Model: Schmidt1		Date: 15-Feb-99	No.: 1
Subject: Service Manual Correction		Prepared by: K. Misugi	
From: GTSS Field Information Dept.			
Classification:	<input type="checkbox"/> Troubleshooting	<input type="checkbox"/> Part information	<input type="checkbox"/> Action required
	<input type="checkbox"/> Mechanical	<input type="checkbox"/> Electrical	<input checked="" type="checkbox"/> Service manual revision
	<input type="checkbox"/> Paper path	<input type="checkbox"/> Transmit/receive	<input type="checkbox"/> Retrofit information
	<input type="checkbox"/> Other ()

This RTB is to inform of corrections to the Schmidt1 service manual.

Model: Schmidt1		Date: 15-Feb-99	No.: 2
Subject: International Access Code for Spain		Prepared by: K. Misugi	
From: GTSS Field Information Dept.			
Classification:	<input checked="" type="checkbox"/> Troubleshooting	<input type="checkbox"/> Part information	<input type="checkbox"/> Action required
	<input type="checkbox"/> Mechanical	<input type="checkbox"/> Electrical	<input type="checkbox"/> Service manual revision
	<input type="checkbox"/> Paper path	<input type="checkbox"/> Transmit/receive	<input type="checkbox"/> Retrofit information
	<input type

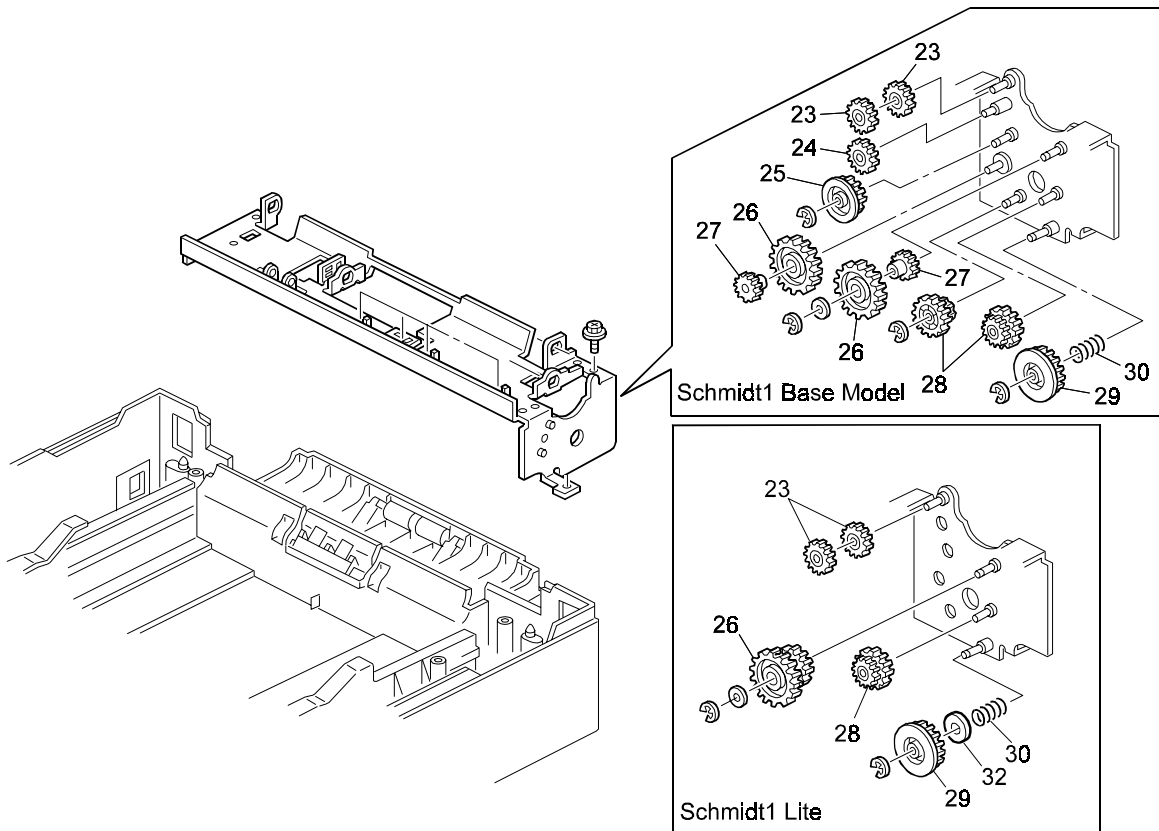
25-25	H5453173	Not used	Idler Gear 1 - 23Z
25-26	H5453171	Not used	Gear 2 - 31Z
25-27	H5453172	Not used	Gear 3 - 16Z
-26	---	H5453199	Slow Down Gear - Lite (Please refer to the following diagram.)

NOTE: Please refer to the following diagram for the location of H5453199 (Index No. 26). This illustration is extracted from page 1-24 of the parts catalog.

RTB Correction

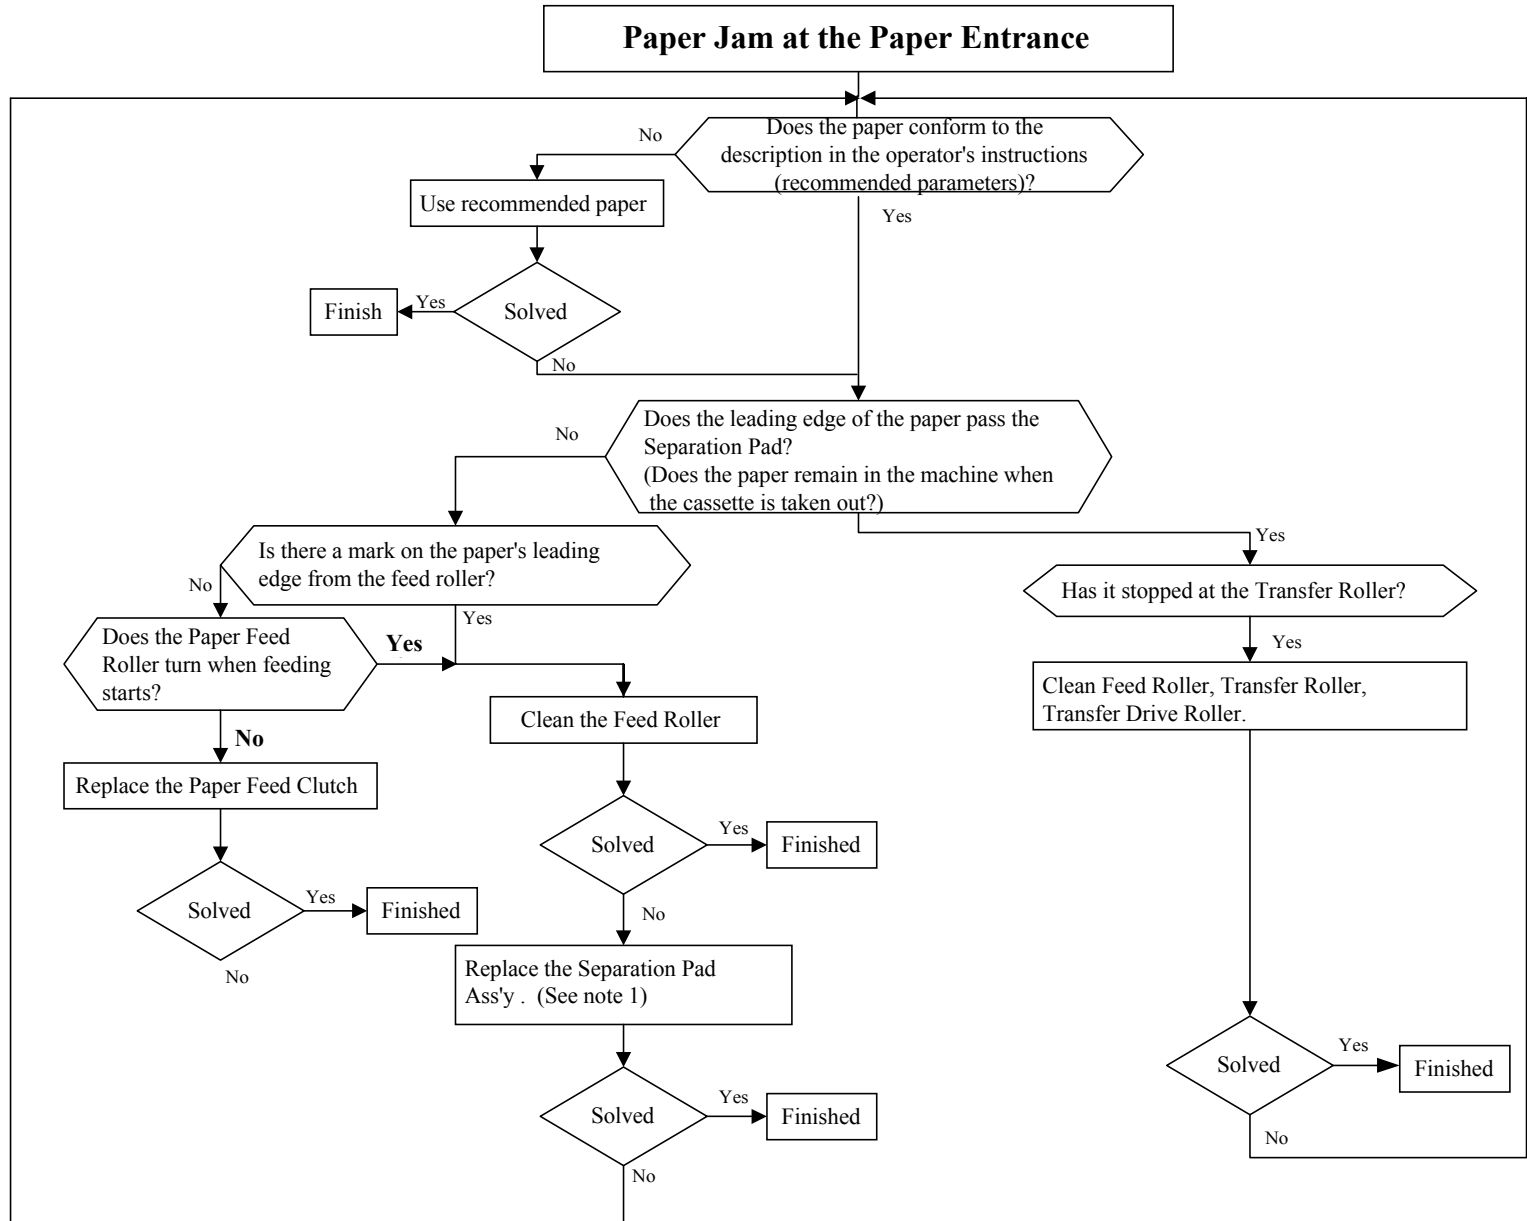
The illustration has changed as shown below.

Installing the new paper feed clutch

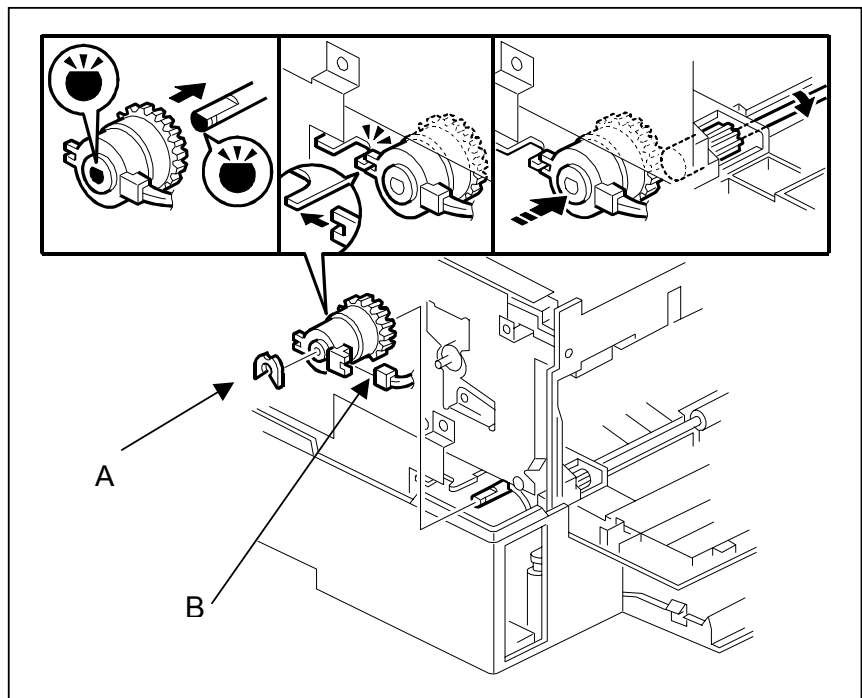
4. Surface of the paper feed roller:
Clean the roller if the surface shows dust or other particles.
5. Replace the paper feed clutch from H5455077 → H5465070:
For easier replacement, see the procedure below.
6. Replace the paper separation pad.
H5453155 → H5463112.

1. Attach the paper feed clutch connector.
2. Mount the clutch onto the D-shaped paper feed roller shaft.
3. Attach the clutch stopper onto the side plate as shown.
4. Adjust the shaft in the clutch hole so that the paper feed rollers rotate.
5. Secure the clutch in place by attaching the plastic clip.
6. Reattach the FCU board, FCU cover and top cover.
